European Association of Automotive Suppliers

Lower tether straps in R129

Paris, 29 June 2022

INTRODUCTION OF LOWER TETHERS IN R129

Amend 6.6.4.4.1.2.1.

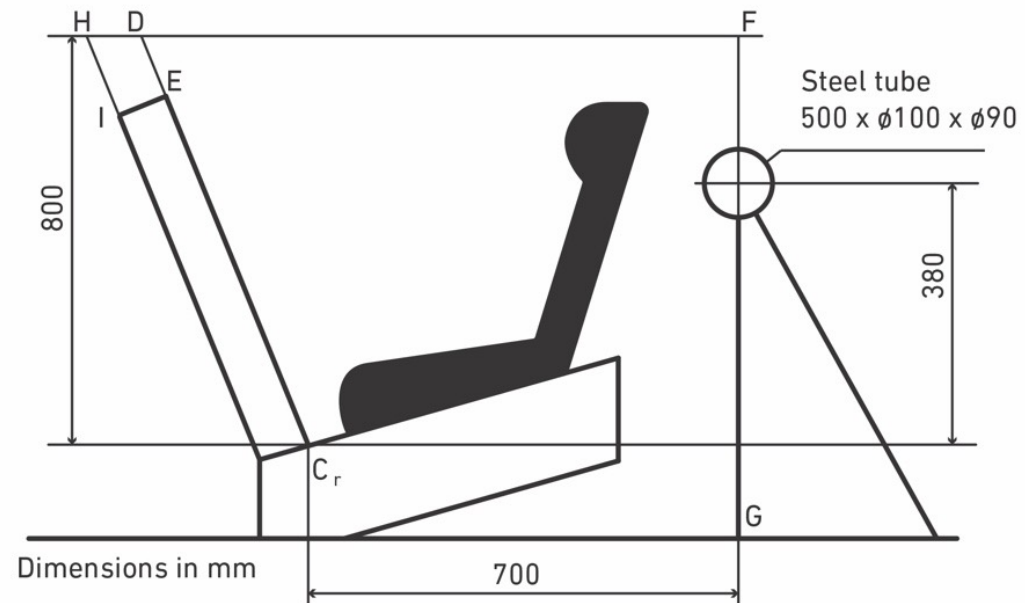
Where a test is conducted with paragraphs 6.6.4.1.6.1.1. or paragraph 6.6.4.1.6.1.2. or paragraph 6.6.4.1.8.2. above, only the second test results without 100 mm diameter bar will be considered. **A tolerance of +10 per cent shall be applicable to the head excursion value distance between Cr point and plane DF and the dummy should not pass beyond the plane HI, parallel to plane DE.**
